AENC-NG-CNS-REP-0061

Norwich to Tilbury

Document: 5.9.31 Draft Statement of Common Ground - MSP
Fairwind Limited - Clean Version

MSP Fairwind Limited (Fairwinds Solar Farm)

Figure 1 – Interface between Fairwinds and the Project Order Limits

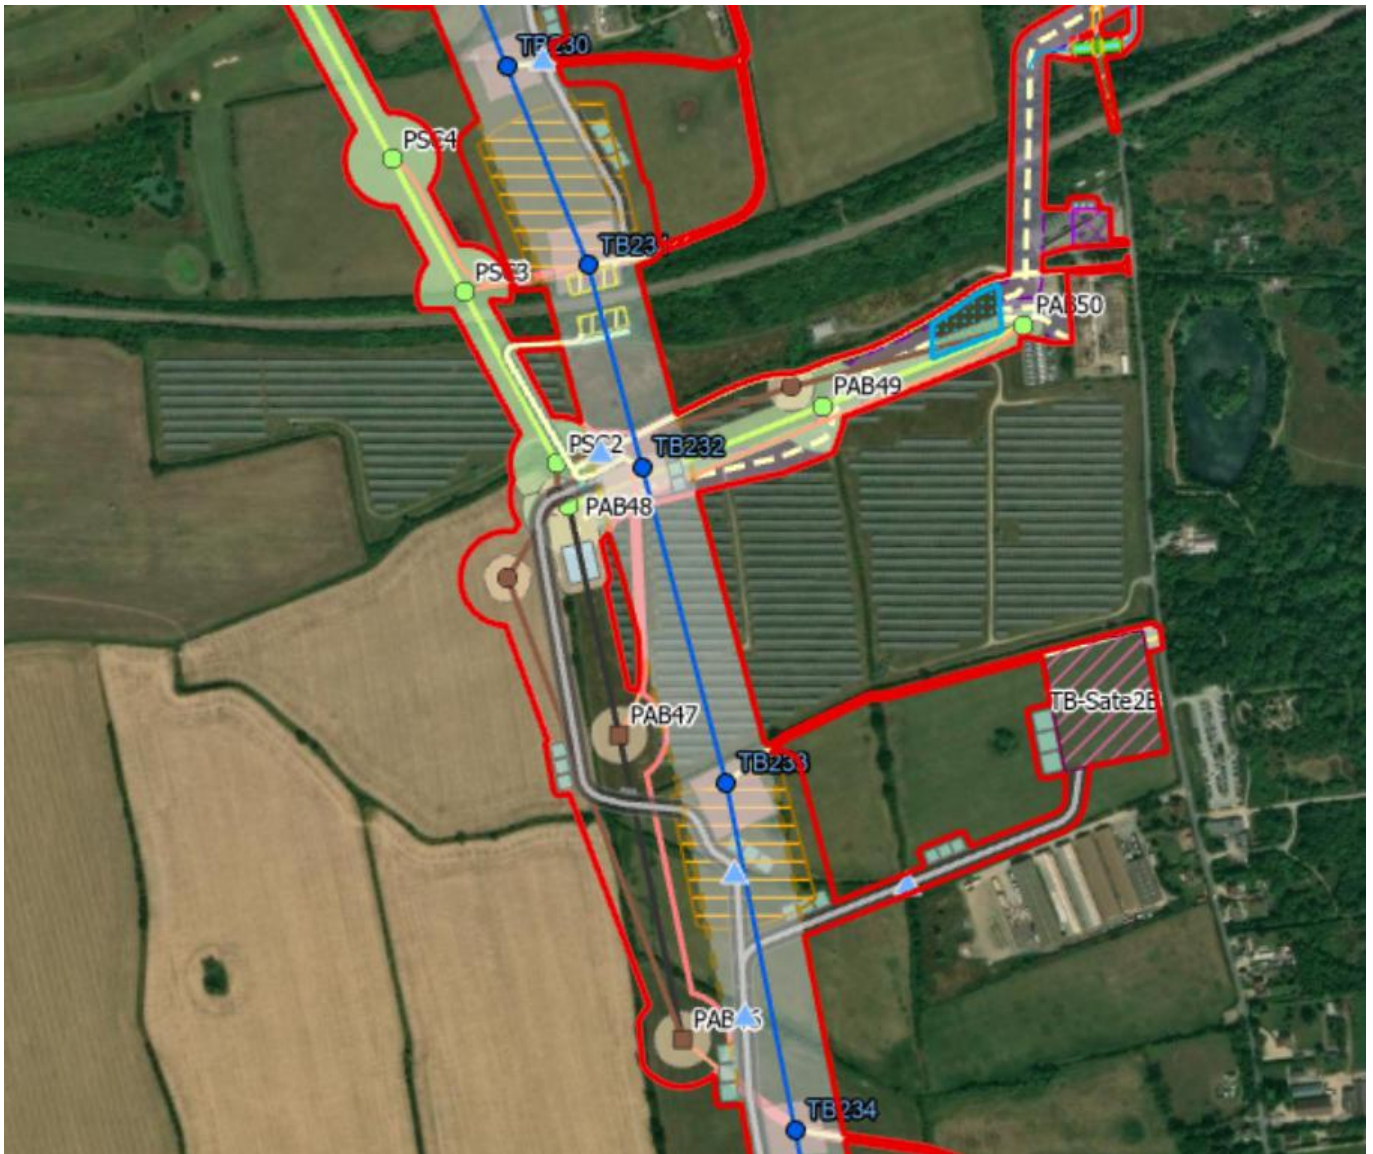
| ID | Issue | National Grid Position | Stakeholder Position | Relevant documentation |
|-----|---|---|---|------------------------|
| 7.3 | <p>Compensation for loss incurred as a result of Norwich to Tilbury</p> | <p>30/06/25 – The Applicant will compensate MSP Fairwind Limited for reasonably assessed and agreed losses incurred as a result of the project across both operational and construction phases of Norwich to Tilbury. The full extent of compensation claim is to be drafted, reviewed and responded to prior to signing of the final statement of common ground.</p> <p>10/12/2025 – Further to the above point made on 30/06/2025, the anticipated tower working area for TB232 is 70m x 70m. On the basis that this provides the construction contractor with the required working area, there is no concern from MSP Fairwind Limited that removal of panels will be required.</p> <p>10/12/2025 – the construction contractor and Vantage (the owners and operators of the solar site are to) conduct detailed studies to assess the extent of the shading</p> | <p>19/06/25 - That an external consultant evaluates the losses and extra costs (e.g.: additional plant-wide module cleaning(s)) to be caused to the solar site and corresponding compensation is issued to MSP Fairwind Limited, both from construction stage and operational stage. For construction stage, MSP Fairwind Limited kindly requires that the impacts to be evaluated include (but are not limited to) increased soiling due to dust generation, extra costs due to additional plant-wide module cleaning(s), maintenance services non-performance due to access restriction to the north portion of the site, increased unavailability due to repair delays caused by access to the north portion of the site. For operational stage, MSP Fairwind Limited kindly requires that the impacts to be evaluated include (but are not limited to) shadowing due to the pylons and overhead line and accelerated PV panel degradation due to hard shadows onto the modules.</p> | |

| ID | Issue | National Grid Position | Stakeholder Position | Relevant documentation |
|----|-------|--|--|------------------------|
| | | <p>impact (especially for the identified tower TB233).</p> <p>The Project will want to assess the anticipated losses stated by the owners and operators of the solar site. This is to include the net impact including any removal of existing 132Kv lattice towers.</p> <p>10/12/2025 – The Applicant requests the owners and operators of the solar site advise what details are required to conduct impact studies so that the Project can advise on a timeline for provision</p> <p>28/04/2026 - If the anticipated working area for Tower TB232 is confirmed as 70 x 70m then the Applicant does not anticipate PV Panel removal will be required.</p> <p>The Applicant recognises Fairwind Solar’s concerns in relation to potential shading implications of the Project on the stakeholder’s solar development.</p> <p>The final pylon design, conductor type and position information is expected to be available in 2027. Once this information is available the Applicant can share this</p> | <p>10/12/2025 – TB233 has been flagged as causing shading and so anticipated losses are expected. TB232 to the north of the site is less of a concern for aspects of shading.</p> <p>10/12/2025 – Vantage queried when a detailed design plan can be provided to their technical consultant so that impacts from the NtoT project can be assessed.</p> <p>28/04/26 - The draft refers to "significant impact". We wish to be clear, shading is a binary technical impact, any shadow on a string of panels causes a loss in generation, and this needs to be assessed in a shading study by a Technical Advisor. Please remove any qualitative language. Furthermore, we cannot wait until Deadline 7 for "tower specs". We require the final height, width, and GPS coordinates of tower TB233 to conduct our own independent yield loss analysis. We maintain our previous request that an independent consultant evaluate impacts and determine fair compensation based on final overlays of the projects and complete technical details.</p> | |

| ID | Issue | National Grid Position | Stakeholder Position | Relevant documentation |
|-----|--|--|---|------------------------|
| 7.8 | Dust Generation and Impact on Solar Panels | Measures to mitigate dust generation are agreed in principle however further discussion is required to determine methodology employed. Compensation for loss of energy generation stemming from dust attributable to the Norwich to Tilbury project to be further discussed prior to final signing of the statement of common ground. | That dust generation during construction is taken into account for the construction phase and that mitigation measures are put in place to reduce its impact, including, but not limited to: humidifying road areas in dry weather, covering with tarpaulin any open top containers transporting sand in the site's vicinity or other equivalent or superior protective measures. In addition, that the potential losses and extra costs due to additional module cleaning(s) are evaluated by the external consultant and corresponding compensation is issued to MSP Fairwind Limited | |
